# Assessment Officer Report

## Permit Application Number PA2402959

Melton Christian College – Senior Secondary Building  
152-156 Brooklyn Road Brookfield VIC 3338

Officer Assessment Report  
Development Approvals & Design

Figure 15: Comparing existing carparking located along the western boundary of the school with proposed extension of car parking area

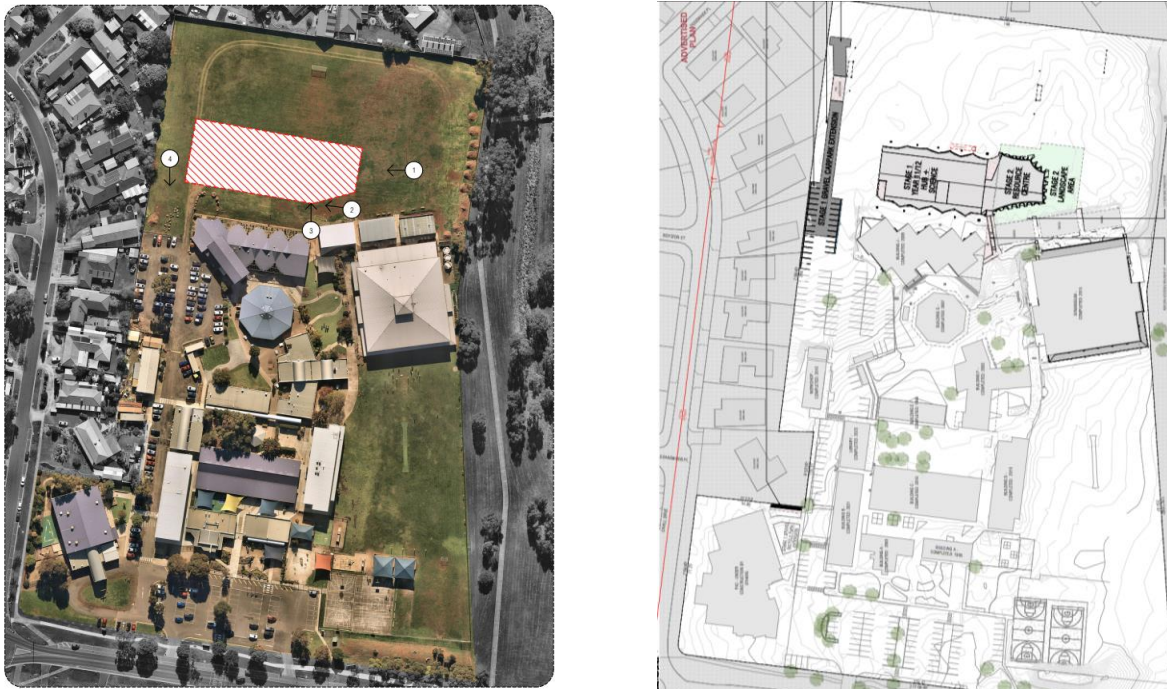
66. The location of the extended car park is at the boundary with two neighbouring dwellings. The extension is minor in scope and a logical extension of the existing car park area, which has the same interface condition. To soften the works at this boundary Melton City Council requested a condition for the landscape plan to be updated to require:

*additional landscaping along the western boundary of the car park and adjoining the proposed new buildings, including the use of canopy trees to soften the impact of the development and add to the permeability of the site.*

This condition is considered reasonable and will be included on the permit.
